ADDENDUM NO. 1

TO: **All Prospective Bidders**
PROJECT: **Avenue G and Station Street Traffic Signal**
OWNER: **City of Port Aransas**
BID DATE: **Thursday, August 7, 2025**

SHEET
E4

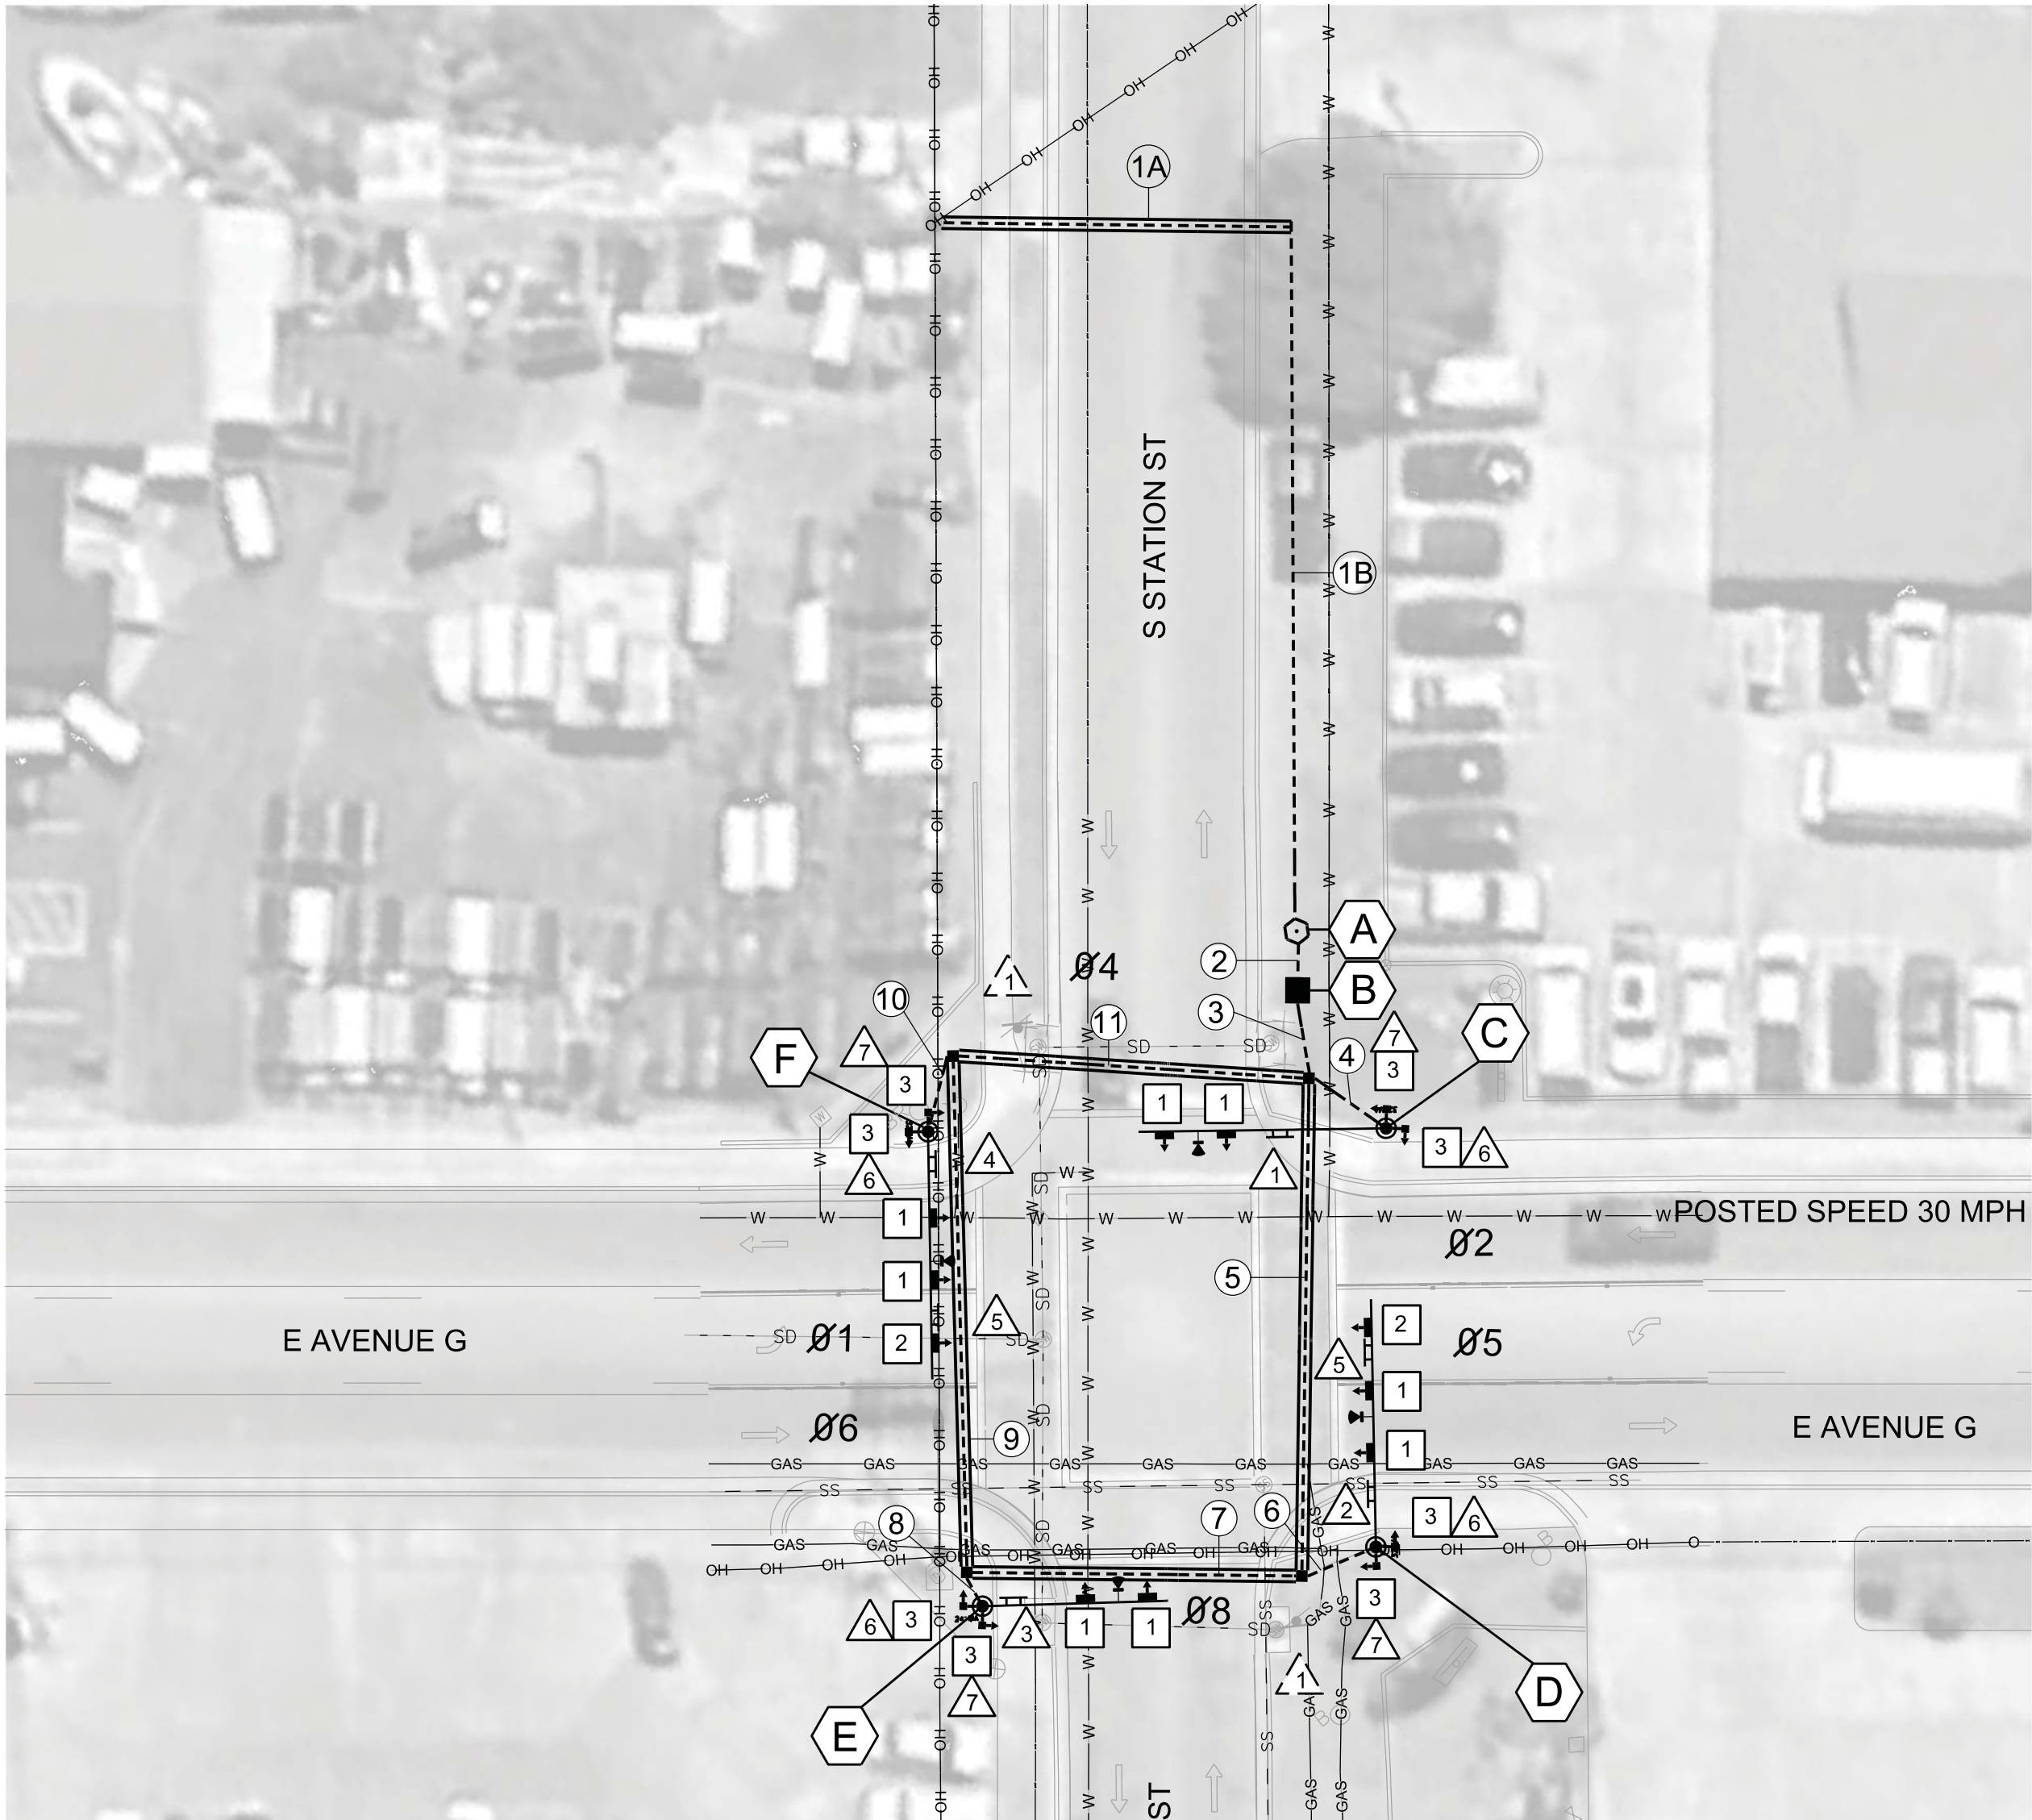
Q: There is no line item for install of Radar/Video camera vehicle detection requested on sheet E4 - 36 Poles C, D, E. It appears that on Pole F, a radar/video camera was not called out...

Plan Sheet E4 and E5 have been updated to show radar/video detection on all four approaches.

A: All approaches will require radar/video detection.

The installation shall be subsidiary to pay item 680-7002 (item 13).
